DEVELOPMENT APPLICATION

PROPOSED MIXED USED DEVELOPMENT:
BASEMENT CARPARK / RETAIL PRECINCT & APARTMENTS (CLASS 7A, 6, 2)

Project
9 MARVELL ST
Client
COBILD

Drawing Name
COVER - CHANGES DRA 01 & 02
Location
9 MARVELL ST BYRON BAY
NSW 2481

Drawing Name
TYPICAL FLOORS - CHANGES
Location
9 MARVELL ST BYRON BAY
NSW 2481

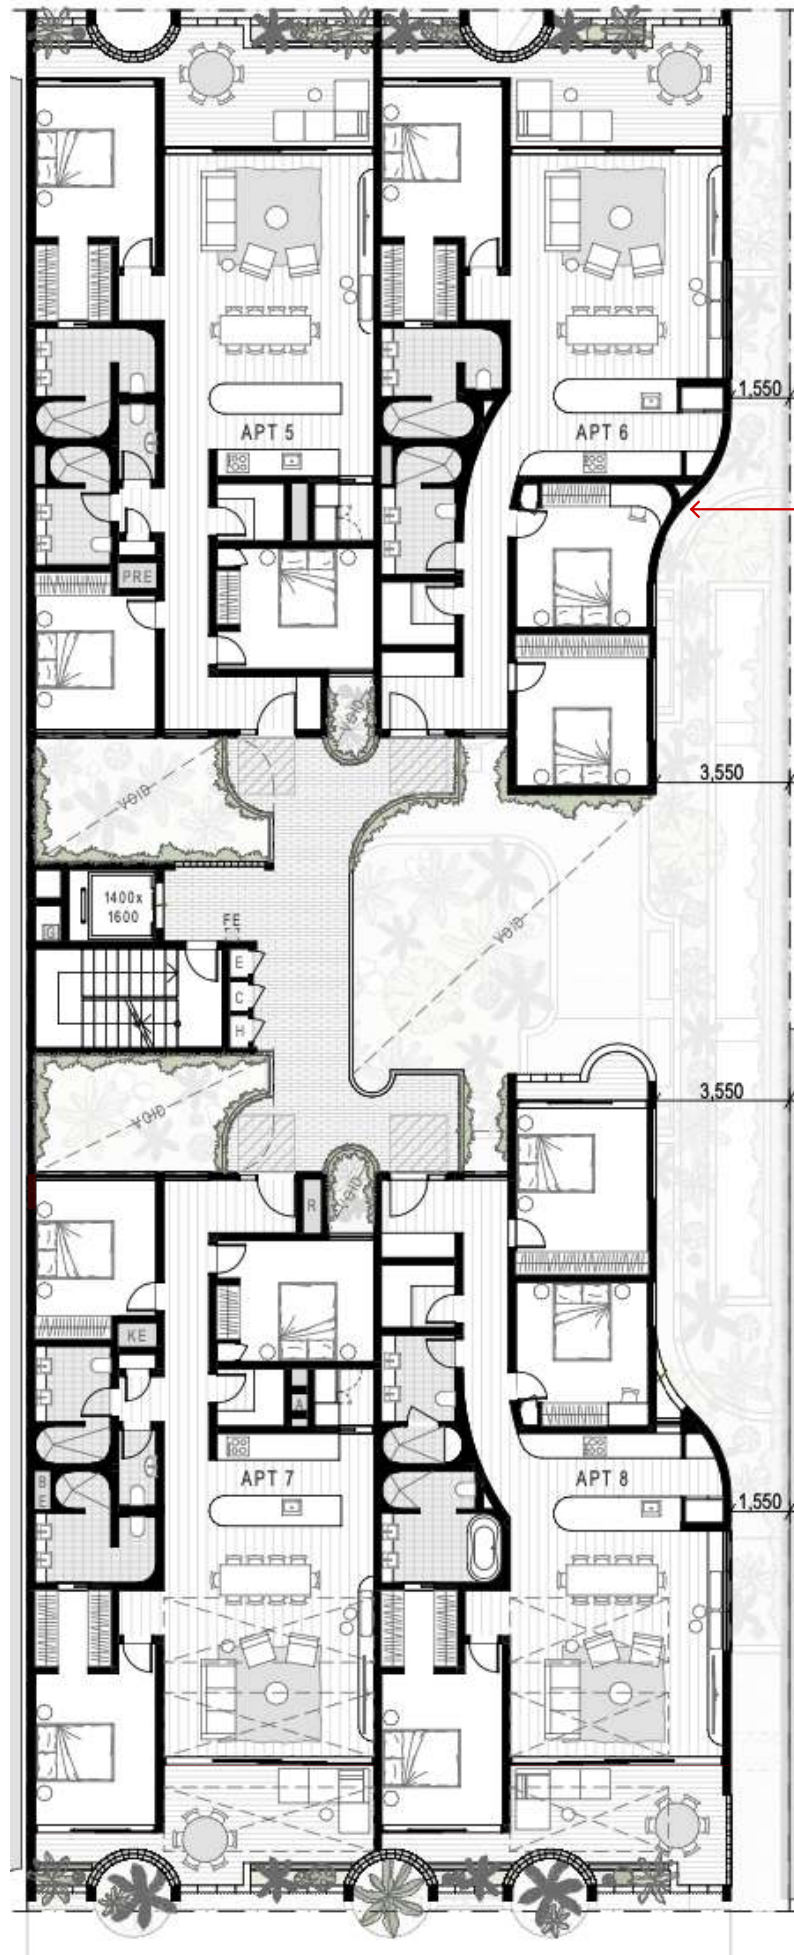
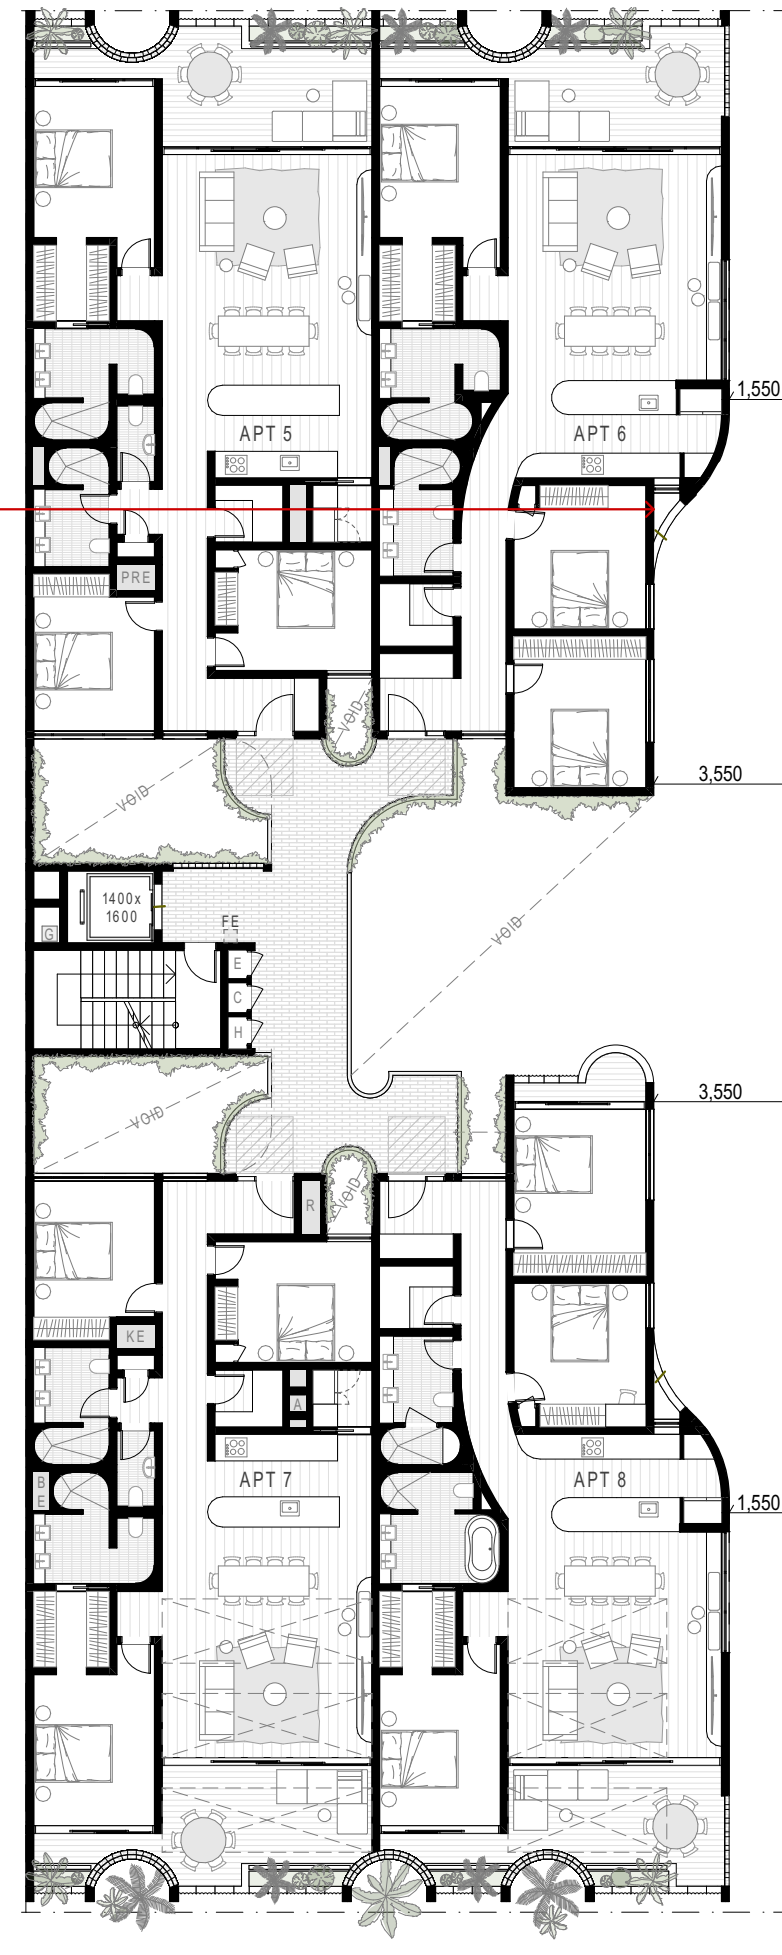
3.14	L1: No potential from borrowed light to light wells adjoining	Noted
3.15	L1: Consider incorporating small window to kitchen in apt 2 & 6 as in Apt 4 and 8	Addressed in updated design

3.15
Introduction of south-facing glazing similar to
apt 4 & 8
